**DEPARTMENT OF TRANSPORTATION
STATE OF GEORGIA**

FILE: CSSTP-0006-00(327) Barrow **OFFICE:** Engineering Services
P.I. No.: 0006327
West Winder Bypass - 3 phases **DATE:** July 16, 2010

SUBJECT: IMPLEMENTATION OF VALUE ENGINEERING STUDY ALTERNATIVES

Value Engineering Responses

West Winder Bypass at Bill Rutledge Rd and Fred Kilcrease Rd

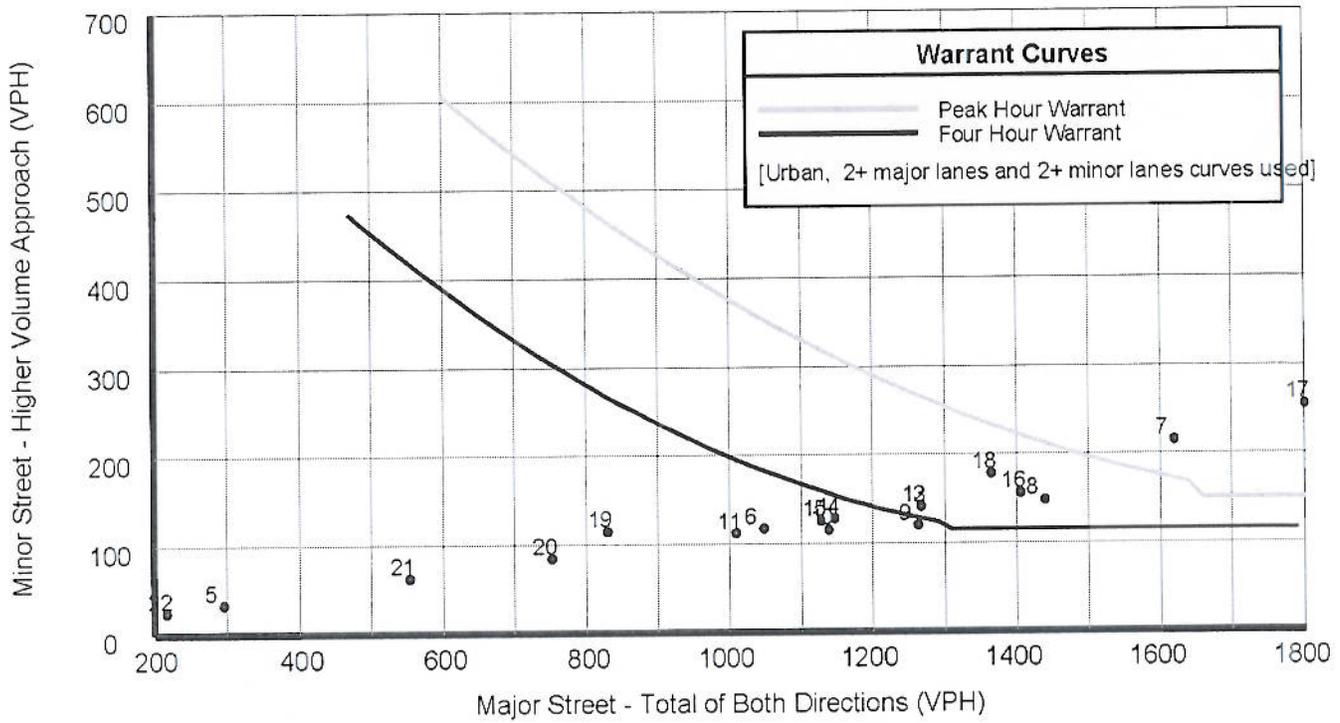
No, will not implement. A traffic signal warrant analysis was performed (see attached) that shows the need for a signal based upon the "build year" traffic volumes. The analysis includes 100% volume threshold and right turn reduction procedures (NCHRP 457).
